Date: January 2, 2018
To: Patrick Gilligan, Lincoln Property Company; Clayton Taylor, West of West Architecture + Design; Bill Poulos, SERA Architects
From: Tanya Paglia, Development Review
503-823-4989
Re: 17-249524 DA – Wells Fargo Center Alterations
Design Advice Request Summary Memo November 30, 2017

This memo summarizes **Design Commission** design direction provided on November 30, 2017.

DP Enclosure Proposed Plan

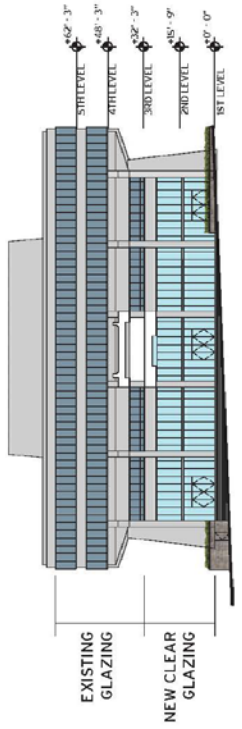
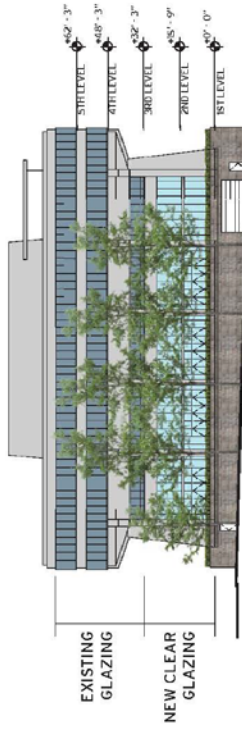
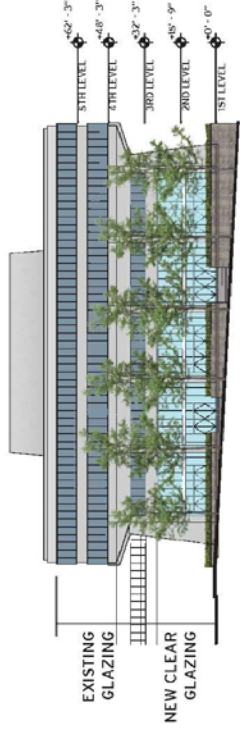
- Overall, the commissioners present supported the enclosure of the plaza space with glass. While some reservations were noted during the discussion, in the end the consensus was in support of the proposed change.

- Commissioners all agreed that bringing glass walls forward towards the street would be a tasteful approach to making the space usable. The proposed glass walls appear light and would allow views into the structure. These alterations would generally make the building more pedestrian friendly which would better meet guidelines.

- The discussion concluded that not retaining plaza spaces would not be a deal breaker for the project with the commission and that the transparency of the glass is going to be critical. The enclosure should be done with "super clear glass," with little to no tint applied.

- Commissioners generally agreed that preserving as much of the original white marble as possible would be critical. The priority would be on what could be seen through the glazed façade of the SW 4th Ave frontage. Due to the existing building's configuration, this might involve moving some of the original marble from other areas towards the 4th Ave side of the building.

- Having the new ground level glazing match the patterning of the upper stories was supported by the commission. There was consensus that the pattern being carried down was sympathetic to the building.

- The commission noted that the ramp area as shown in the proposal, segregated in the corner of the site, was an ADA solution that is very dated. It was equal but not equitable. Commissioners were favorable to the applicant's response that there are ways to elongate the ramp and blend it with the stairs, and that these would be explored prior to a Type III submittal.
